Staff Report to the Plan Commission

Fernway Park Elementary School Expansion

Project: 2024-0807 Fernway Park Elementary School Expansion

SITE PLAN

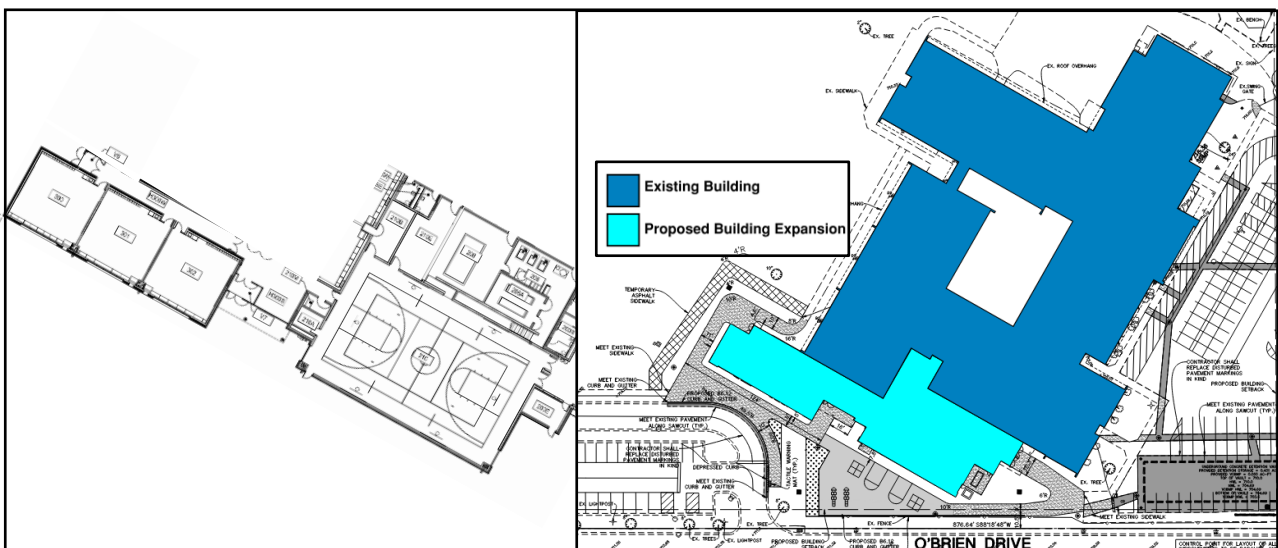
The proposed expansion extends the building south to accommodate a new gymnasium, allowing the gym and the existing lunchroom to function as separate spaces. The expansion also includes three additional classrooms, one office, and mechanical rooms. The main school building and parking areas are located along 88th Avenue, and the bus drive is accessed from O'Brien Drive. The access points will remain unchanged, except for the improvements to pedestrian and bicycle accessibility on site.

The proposed building expansion will decrease the south and rear setbacks; however, both will continue to exceed the minimum requirements of the R-2A District. No changes are proposed to the layout of the parking lot or to the north and east setbacks.

Pedestrian and Bicycle Mobility

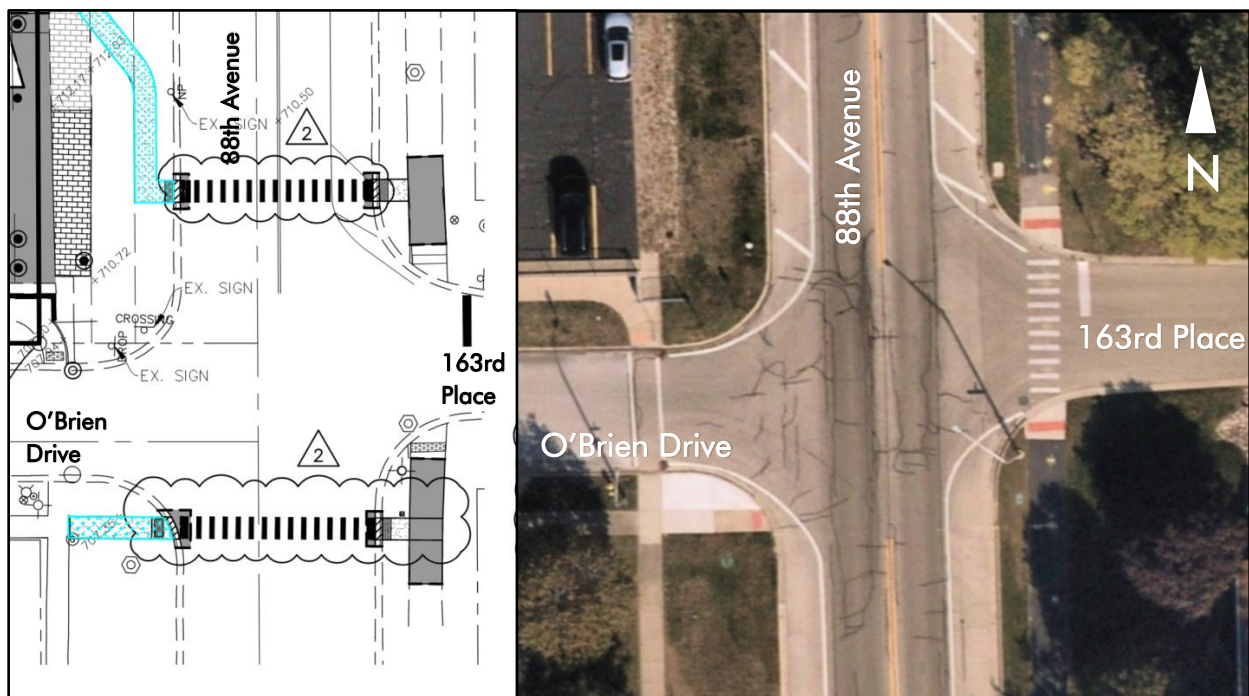
The site currently has a partial sidewalk along the southern property line near O'Brien Drive, but lacks continuous public sidewalks within the right-of-way on 88th Avenue. Staff has requested that the petitioner install the missing sidewalk along their 88th Avenue frontage. As part of the sidewalk expansion, two new crosswalks are proposed at the north and south sides of the 88th Avenue and O'Brien Drive intersection, providing a connection to the existing bicycle path on the east side of 88th Avenue. A sidewalk connection at the northwest corner of O'Brien Drive and 88th Avenue could not be provided due to existing topography, drainage conditions, and the current parking lot layout. Future site improvements should consider adding a sidewalk connection in this area.

An additional crosswalk is proposed at the intersection of 88th Avenue and 163rd Street at the north end of the school property, to provide a safer and more visible crossing point for pedestrians. As part of these improvements, the existing mid-block crosswalk near the main entrance will be removed, improving overall traffic safety. These enhancements directly support the Comprehensive Plan goal for the Fernway Planning District by promoting safer, more accessible non-motorized travel routes for students and the surrounding neighborhood. To further ensure pedestrian safety, crossing guards will continue to be present during student drop-off and pick-up hours.
